MIL-L-6363/11
Amendment 1

3 September 1993

MILITARY SPECIFICATION SHEET

LAMPS, INCANDESCENT AIRCRAFT SERVICE, SINGLE CONTACT, BAYONET CANDELABRA BASE, G-6 BULB

EXAMPLE

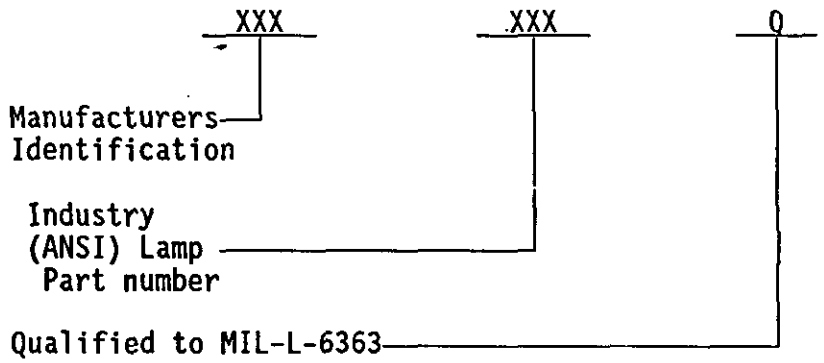
Requirement 11 Marking.

Delete - "To be determined for marking of production lamps," and rest of paragraph.

Substitute the following:

"11. Marking. Production lamps qualified to MIL-L-6363 and listed on QPL-6363 shall be marked in accordance with ANSI/NEMA C78.390 and as supplemented herein. ANSI/NEMA C78.390 authorized suffix letters shall be supplemented with the letter "Q" (MIL-L-6363 QPL item). The letter "Q" shall be incorporated into the method of designation in accordance with the following example:
